**000764-20**

Note: (2) Different B-0290 Seats, as of March 1997

Product Specifications:  
B-0290 Removable Seat

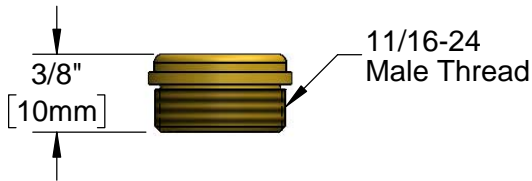
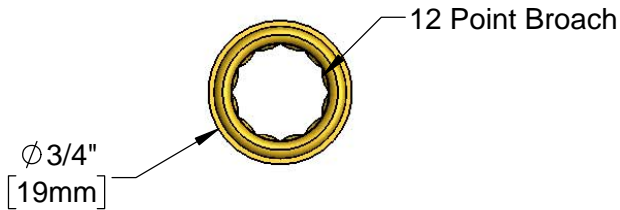
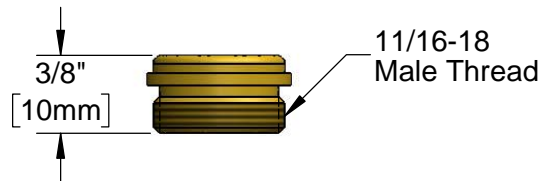
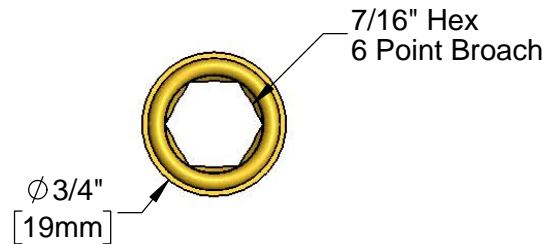
Broach  
Threads      12 point  
                  24 per Inch ○

6 point  
18 per Inch ◡

Old Seats Only Fit Old Faucets. New Seats Only Fit New Ones. Since We Weren't Sure Which Body You Would Be Repairing Today, We Have Included Both Types.
